Product Change Notification

Bourns® Trimpot® Product Line Announces TC33 Product Change

Figure 1: Current versus New TC33

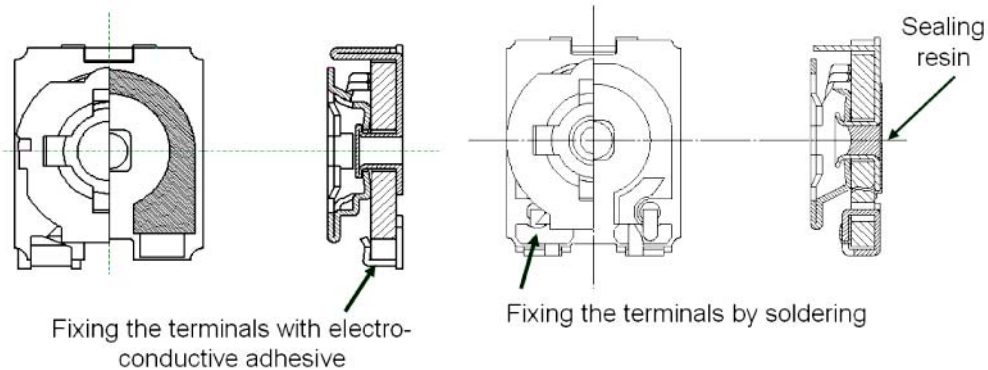
Bourns is pleased to announce a product improvement on [Model TC33](#). The current TC33 joins the terminals to the ceramic with an electro-conductive adhesive. The new version will solder the terminals in place. Another improvement is the addition of a sealing resin on the bottom of the trimmer. The sealing resin will add support to the rotor.
